Access Compliance Report

Public Rights-of-Way

Intersection ID: 27422	Main Street: BALLANTYNE COMMONS PY	Cross Street: STONEBRIAR DR	Location: SW
ADA ID: 37D9694A80CB	Ramp Type: Perp	Initial Pass/Fail: Fail	Overall Compliance: No
		Severity Score: 12.5

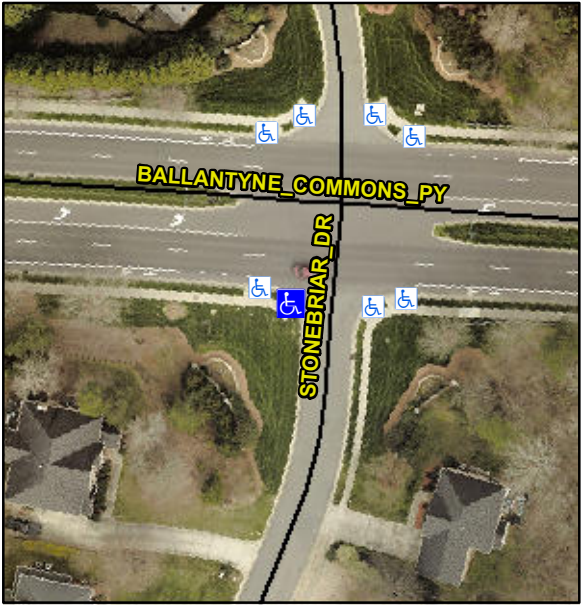
Codes/Mitigation Info/Possible Solution		Field Measurements/Component Compliance			
	Possible Solutions:				
	Remove & Replace Entire Ramp.				
	Surveyor Notes:				
	N/A				
	PROW/ADA:				
	Not Found, R304.2.2				
Street 1 Name	STONEBRIAR DR				
Stop Condition-Street 2	StopSign				
Street 2 Name	N/A				
Stop Condition-Street 1	N/A				
Total Cost:		\$	1850.00

Compliance	Description	Data	Compliance	Description	Data
N/A	Ramp Length (in)	105.0	No	Ramp Slope (%)	11.6
Yes	Ramp Width (in)	48.0	Yes	Ramp XSlope (%)	0.7
N/A	Flare Type LT	N/A	N/A	Flare Type RT	N/A
N/A	Flare Slope LT (%)	N/A	N/A	Flare Slope RT (%)	N/A
N/A	Flare Traversable LT?	N/A	N/A	Flare Traversable RT?	N/A
N/A	Landing Length (in)	N/A	N/A	DWS Provided?	N/A
N/A	Landing Width (in)	N/A	N/A	DWS Contrast?	N/A
N/A	Landing Slope (%)	N/A	N/A	DWS Length (in)	N/A
N/A	Landing X Slope (%)	N/A	N/A	DWS Full Width?	N/A
N/A	Landing Curb? (Y/N)	N/A	N/A	DWS Offset (in)	N/A
N/A	Shared Landing?	N/A			
N/A	Gutter Ponding?	N/A	N/A	Gutter Slope (%)	N/A
N/A	Gutter Lip Ht (in)	N/A	N/A	Gutter X Slope (%)	N/A
N/A	Painted X Walk1?	No	N/A	Painted X Walk2?	N/A
	X Walk 1 Direction	To E		X Walk 2 Direction	N/A
N/A	X Walk 1 Width (in)	N/A	N/A	X Walk 2 Width (in)	N/A
	X Walk 1 Slope (%)	2.0		X Walk 2 Slope (%)	N/A
	X Walk 1 X Slope (%)	3.7		X Walk 2 X Slope (%)	N/A
